GAS MEMBRANE VALIDATION

Site Name: Belle Vue Stadium	Project Number: 12-123
Company Name: Countryside	Date: 15-02-2022
Project Manager: O. Jackson	E3P Engineer: T. Preston
PM Qualifications : BSc FGS AMIEnvSc	Engineer Qualifications: Verification of Gas Protection Systems Dec 2017
Ground Gas Risk Assessment: Amber 1	
<p>Overview: The membrane comprised a Visqueen low permeability gas membrane (Yellow) resistant to radon, carbon dioxide and low levels of methane. E3P can confirm there were no holes or rips at the time of inspection. Upon being laid the membrane is to be covered with a Celotex (closed Cell) floor insulation material which is considered to provide a high degree of protection.</p> <p>All external joints were inspected and E3P can confirm that the membrane was overlapped and double taped to external and internal gas resistant DPM. The membrane was taped to the gas resistant DPM using a double-sided jointing tape. Corners of the plots were sufficiently sealed and taped.</p> <p>Each unit has a service duct located to the front and outer edge of the property. E3P inspected each one and can confirm that the top-hats have been adequately sealed against the membrane.</p> <p>

Plot - 242

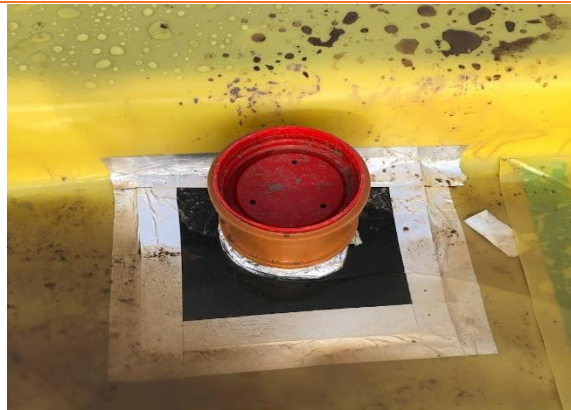
General Condition of Membrane-Good Condition

Verification of Joints and Seals-Overlapped and sealed correctly

Verification of Service Penetrations-Good Condition

Verification of Ventilation-Good Condition

Plot - 243

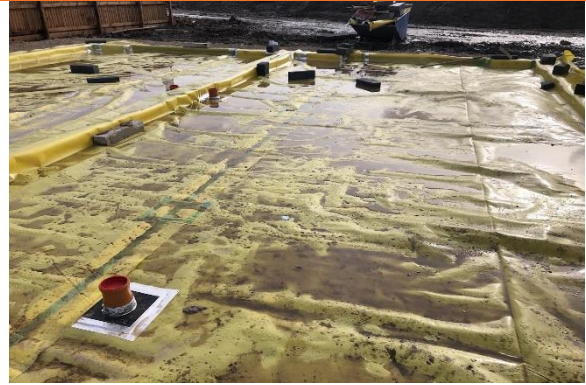
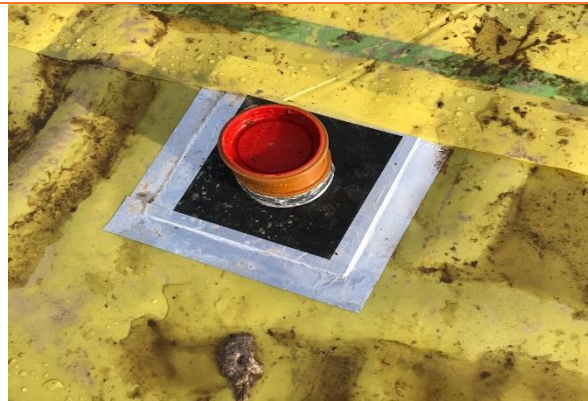
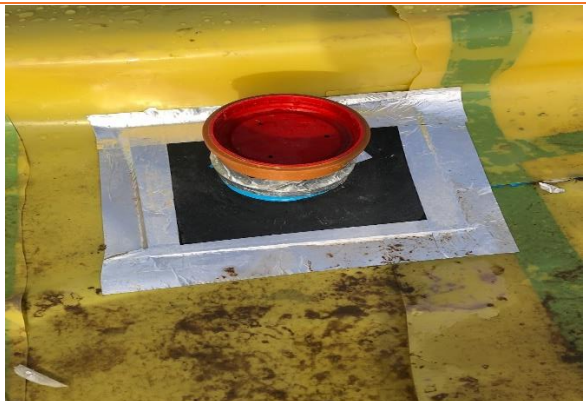
General Condition of Membrane-Good Condition

Verification of Joints and Seals- Overlapped and sealed incorrectly

Verification of Service Penetrations-Good Condition

Verification of Ventilation-Good Condition
